# 1963 - 1965 Corvette: Service Bulletin: Drive Line Noise

**Subject:** Drive Line Noise  
**Model and Year:** 1963 - 1965 Corvette  
**Source:** Chevrolet Technical Service Bulletin  
**Bulletin No:** #1069  
**Section:** IV  
**Date:** January 7, 1965

FIGURE 1

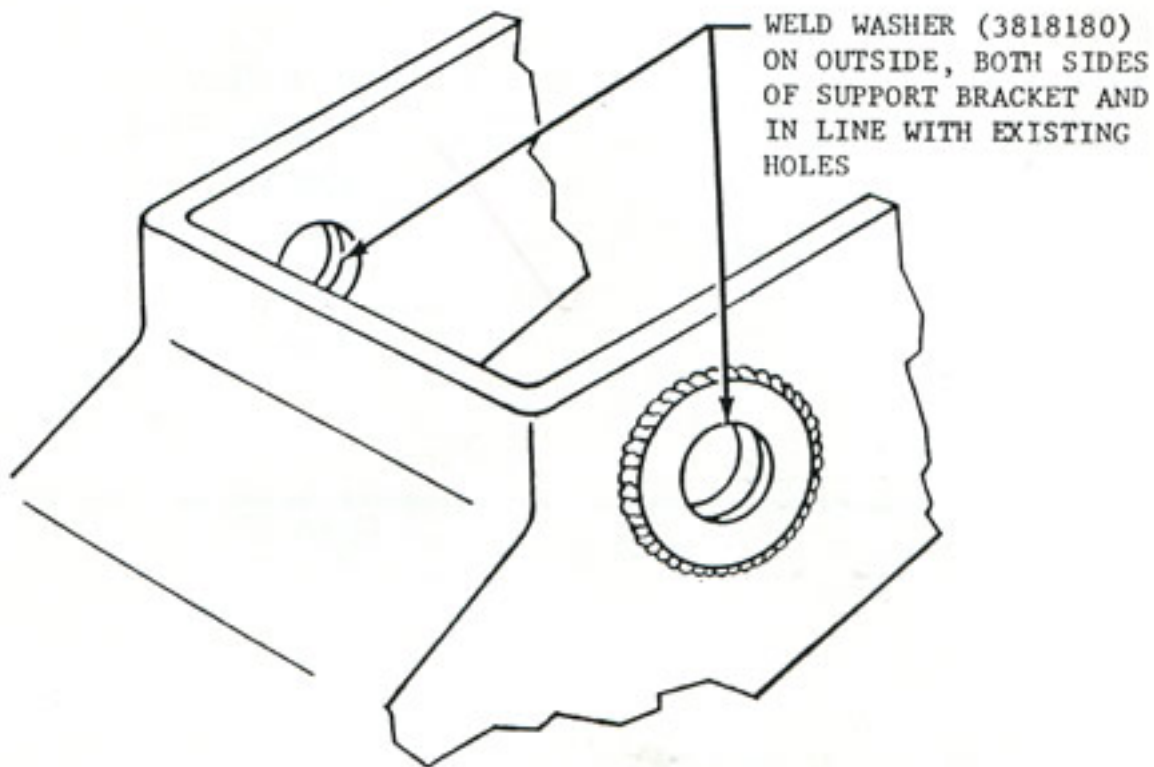
1. If reinforced bracket, Part No. 3868799 is not available, obtain Part No 3820186 and weld one flat washer, (Part No. 3818180) on each outside surface in line with existing holes (See Figure 1.)

FIGURE 2

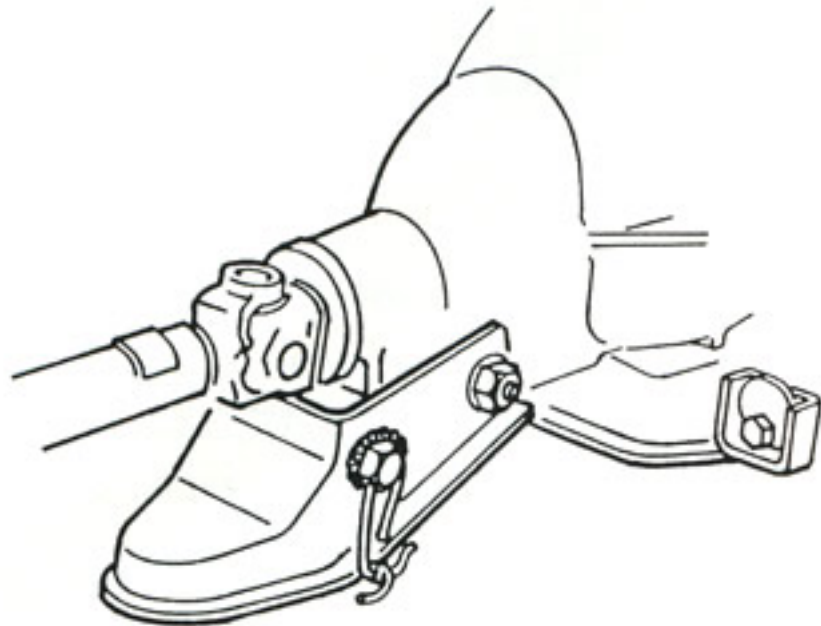
NOTE: Be sure the straight wire form the bolt head to the flange hole is on the tightening side of the bolt. (See Figure 2).
